# SITE/SOIL EVALUATION FOR ON-SITE WASTEWATER

*Plot Plan*  
**Price Construction Company**

*Sierra Villa Subdivision Section Nine*  
*PC # F Slide 266-B*  
*Anderson Creek*  
*Harnett* *Township*

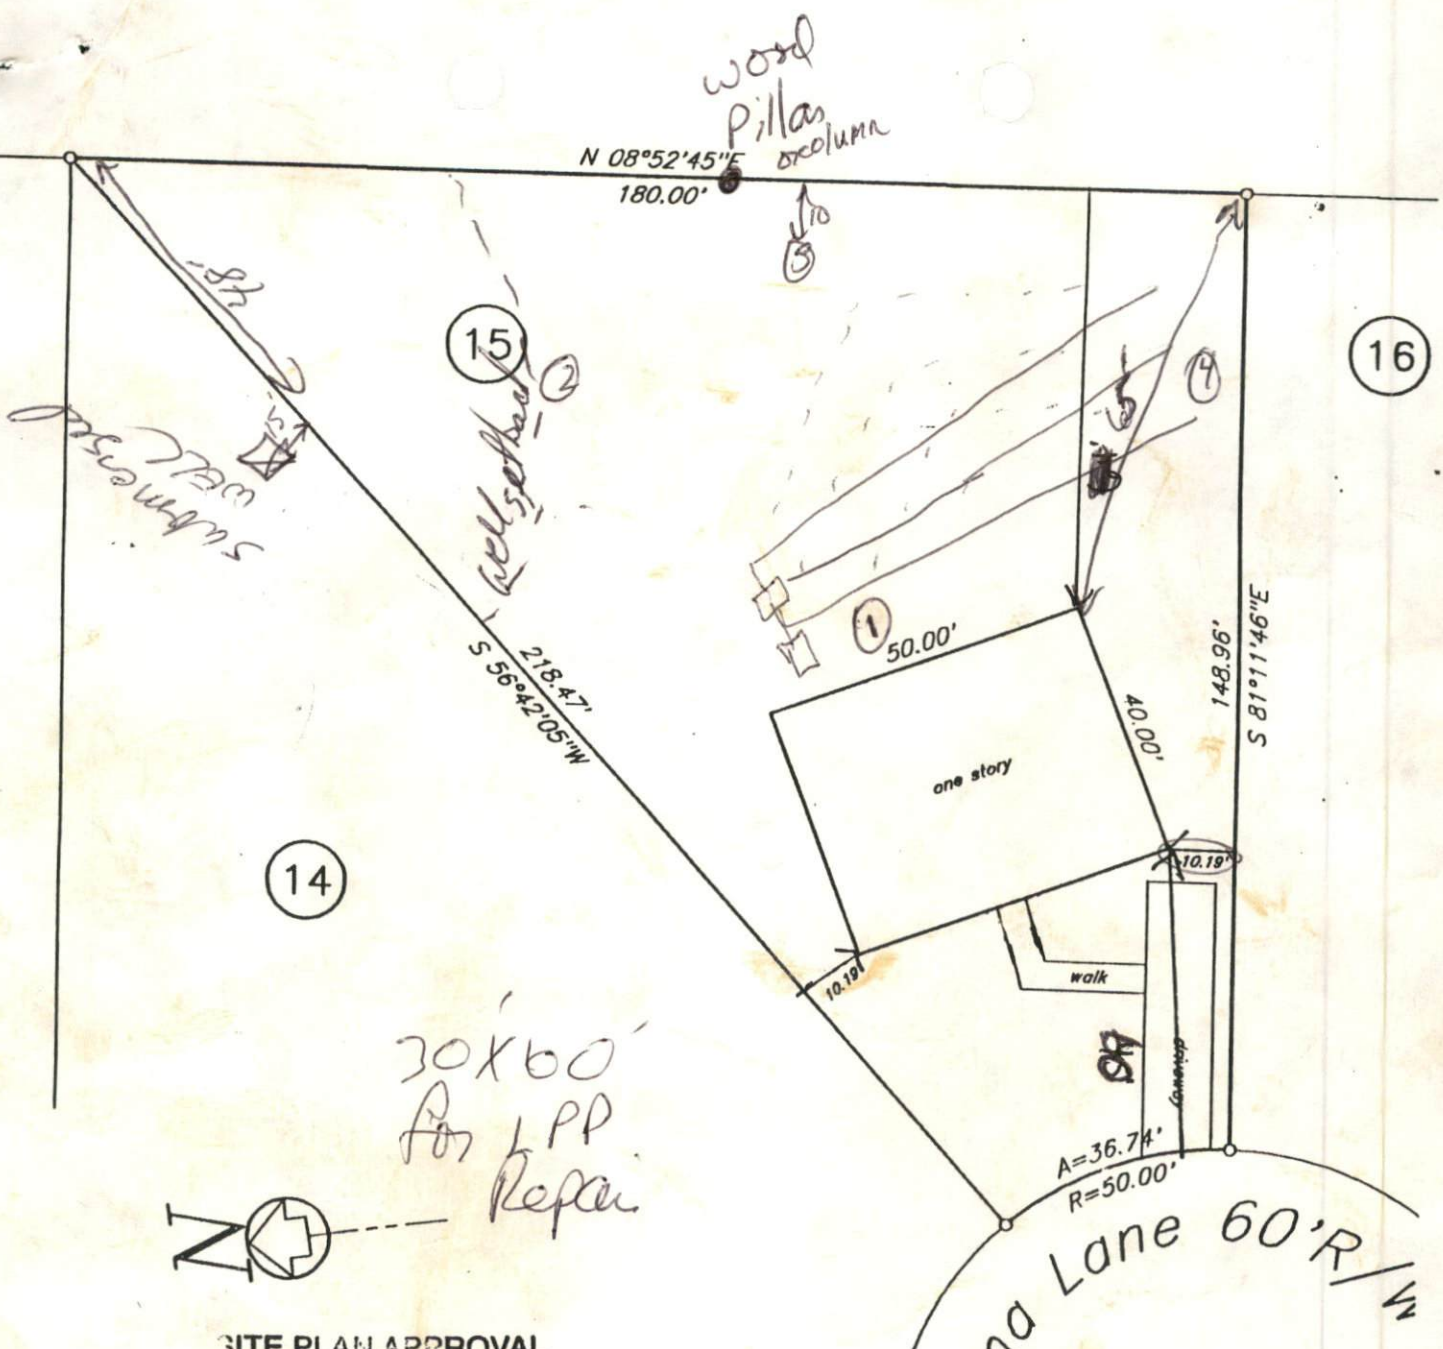
Watch for well → Ash T.B.

where is neighbors drainfield

3x100' lines  
18-24' deep  
no fall → pump

check for well setback  
by legions out

30x60'  
for PP  
Repair
